**CITY OF TEMPE  
DEVELOPMENT REVIEW COMMISSION**

Meeting Date: 06/14/2016  
Agenda Item: 4

**ACTION:** Request for a Development Plan Review and Use Permit Standard for increased building height for a new three-story, 9 unit multifamily development and an existing dwelling unit for SMITH ROAD APARTMENTS, located at 940 S. Smith Rd. The applicant is Fred Woods.

FIRST FLOOR PLAN

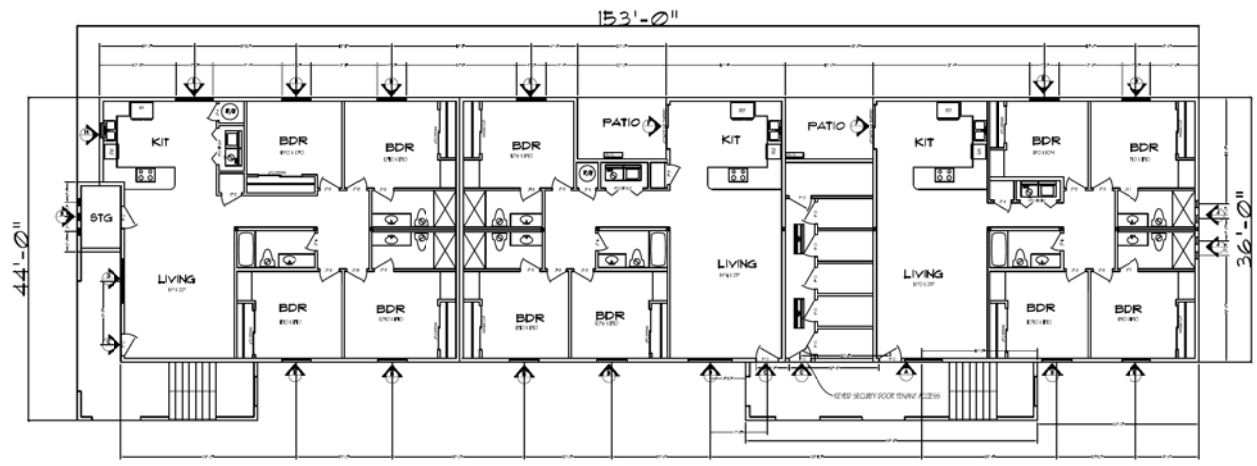
- Per prior SPR comments, modify the interior floor plans to incorporate the storage into the individual living units. With the exception of this one additional comment, the applicant made all changes indicated from the final site plan review.

9. Revise interior floorplan of the new building to incorporate storage space within each unit, not as individual storage spaces separate from the dwelling units.
10. Secure area under stairwells to prevent access.

CONCEPTUAL  
 LANDSCAPE  
 PLAN

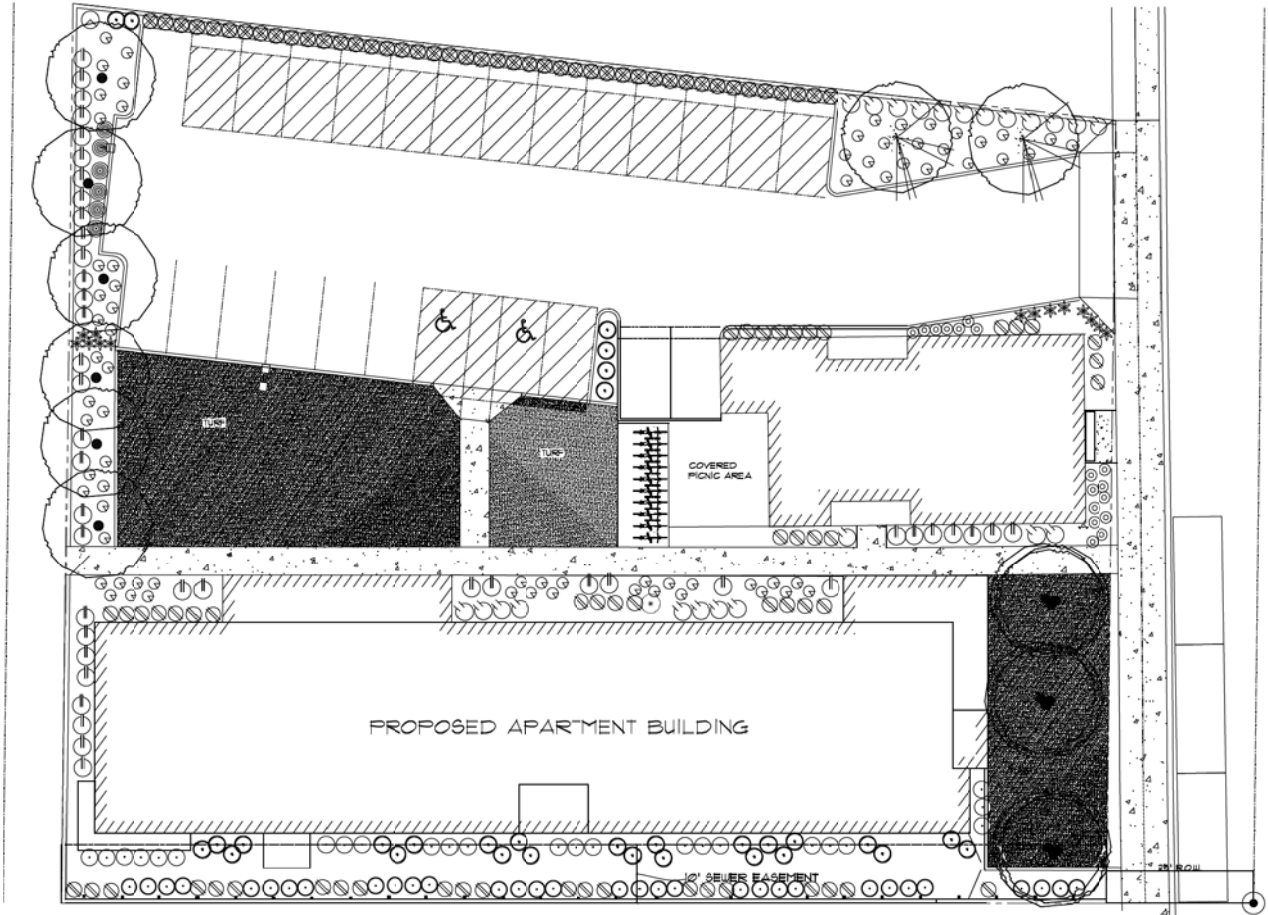
- Landscape plan should reflect size of mature plant species, provide minimum of 60% mature vegetative coverage in smaller planting areas, review plant height requirements in code pertaining to safety for pedestrians, and consider different species in areas of greater expected shade. Recommendation for turf along east side of the new building.

EAST ELEVATION-SMITH RD.

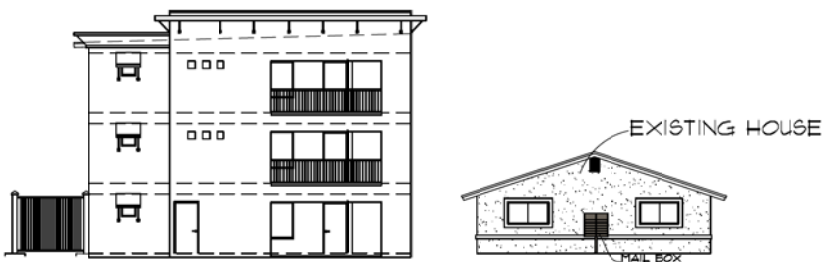
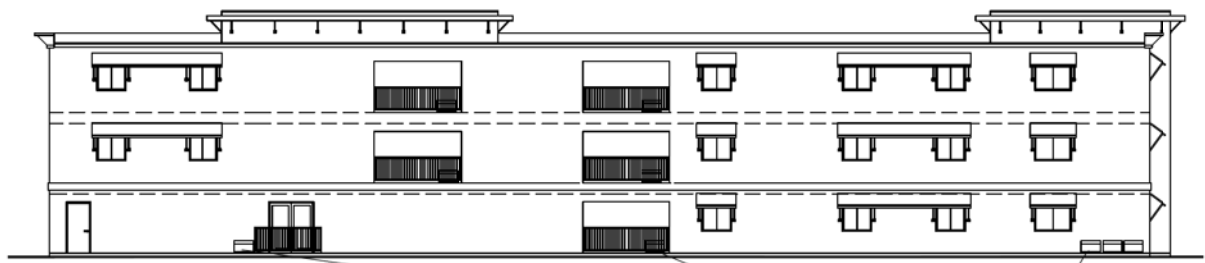
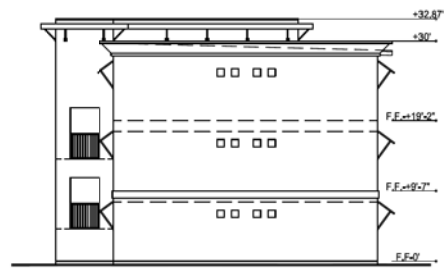
- Elevations show building height measured from finished floor, not top of grade. Verify building height and dimension elevations and sections to show heights per code definition. Use Permit Standard required for building height above 30' in R-3 Zoning District. The applicant verified the height and applied for the Use Permit Standard to allow the additional height.

- Staff recommended larger shade awnings over multiple windows, rather than individual canopies over small windows, and advised that shade on the south side elevation should not be limited to the top floor units but provided over windows on all floor levels.

Parapet at rooftop was modified and elevations changed to provide more building articulation. Recessed balconies were added. Colors were changed to a more contemporary taupe palette with subtle variations between building wall planes. Canopies were enlarged on south elevation and included on all floors, canopies were added to all windows on north side, and the living room windows were enlarged. Doors to the east end units were rotated to face Smith Road with covered patio areas at the entrance, providing eyes on the street for pedestrians and vehicles parked on the street. HVAC units and mailboxes were shown on plans. Shade canopies were provided over the majority of parking spaces. Turf and shade trees were added along the street frontage. No changes to the material or the general form of the structure were provided. Most comments were addressed in the May 16<sup>th</sup> resubmittal however the unit floorplans were not modified. The applicant wishes to keep the proposed interior unit configuration, which is outside of the planning purview. For security purposes, lighting and a door was added to the storage area; however police staff indicated having residents enter the confined area to get a bike or boxes would leave them vulnerable in an area with little activity. Staff has conditioned that the bike storage lockers be incorporated into the units rather than being allocated per bedroom in a separate space.
